**CHANGE
ORDER**

PROJECT:
Crossover Road Improvement Project
From FM 1463 to Katy Flewellen Road
(Spring Green Boulevard)

CHANGE ORDER NUMBER 002

PROJECT NUMBER 13307

PLAN & PROFILE
 STA 30+00 TO
 STA 35+00

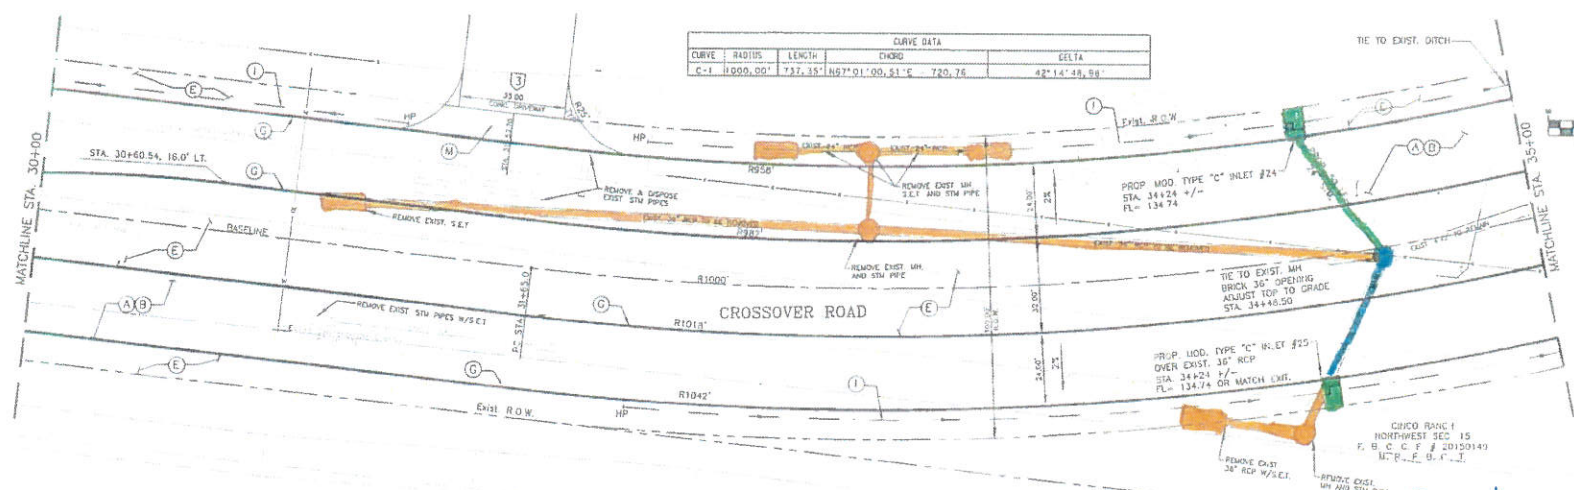
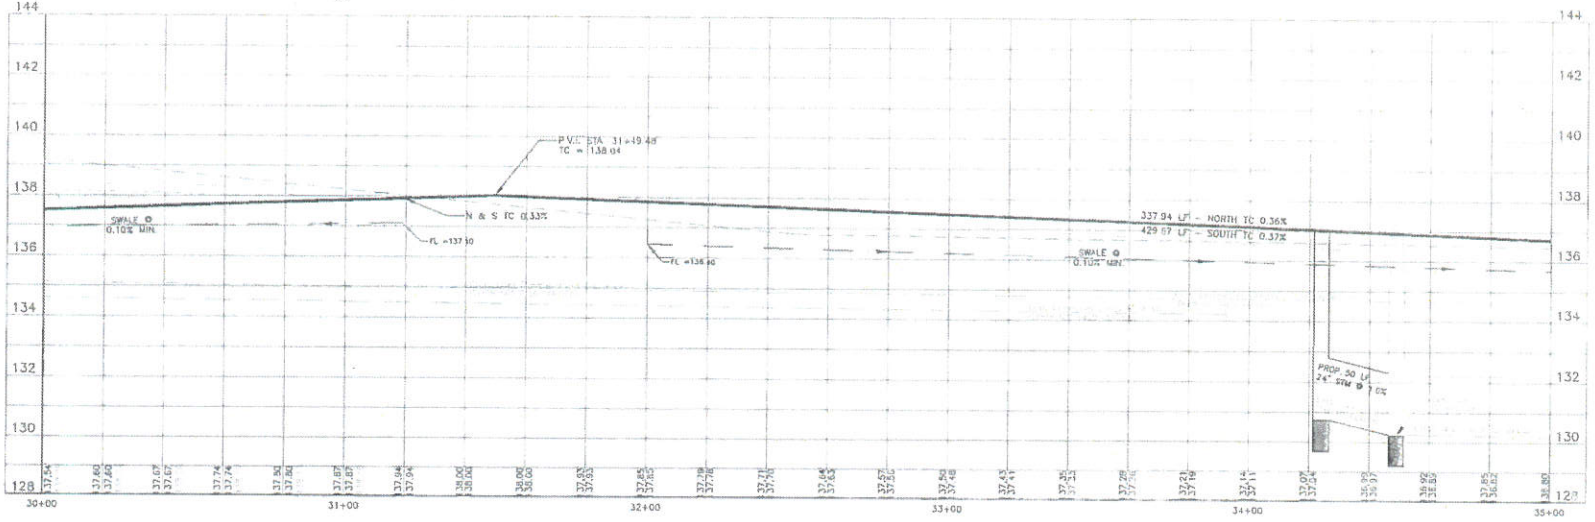
The Spring Green Boulevard Expansion Project (Project No. 13318) plan sheet 21 and 22 proposed to install 24" and 36" RCPs with SETs to provide temporary drainage in the area prior to Crossover Road construction and should be removed during the construction of Crossover Road Project. However, the temporary storm sewer was not shown on Crossover Road original plan, which caused conflict with the new proposed Crossover Road roadway (sheet 20 and 21). To resolve this issue the design engineer proposed to remove the installed temporary storm sewer, along with four (4) SETs, three (3) Manholes, and 460 LF of RCP see revised sheet 20 and 21 (attachment).

A manhole at Station 34+48.50 and a 4'X2' RCB trunk line was also installed as part of the Spring Green Extension Project temporary storm sewer system, both are located inside the Crossover Road proposed median and not in conflict with the proposed roadway. The design engineer proposed to keep the 4'x2' trunk line, modify an existing 36" RCP from this manhole to connect to a Modify Type C Inlet #25 at Station 34+24, 40 RT, and modify the manhole to add 50 LF of proposed 24" RCP to connect this manhole to a proposed Modified Type C inlet #24 at Station 34+24, 40 LT, see revised plan sheet 20 and 21 (attachment). The cost for additional work is summarized below:
